Service Bulletin

Eaton®
Transaxles

May, 2000

Subject: Discontinued— Transaxles 750, 850, 780, and 770

Discontinued and Replacement Transmission — Some Rework Required

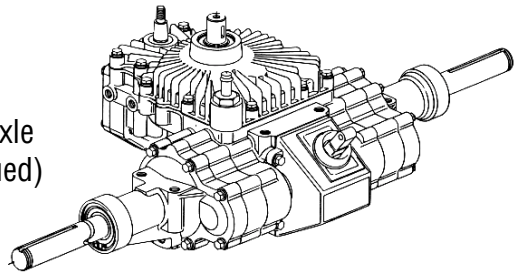
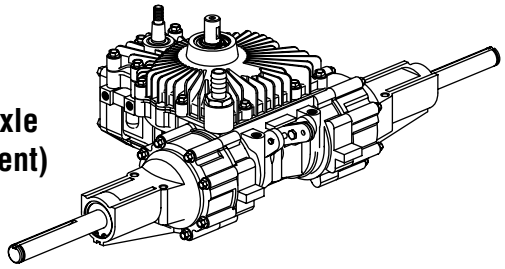
The early Transaxles 750, 850, 780, and 770 had been in production from 1988 to 1991. Replacement parts on these units are no longer available. Transaxles 751, 851, 781 and 771 are available as replacement units. However, these units will not bolt on without some modifications.

- Input shaft diameter is 17mm not 3/4 inch.
- Parking brake linkage connections and actuation angles differ.
- Differential lock is no longer an available option.
- Axle mounting points are similar but mounting hole modifications are required.

Reservoir connections, control shaft and axle diameters are common between the old units and the replacement transaxles.
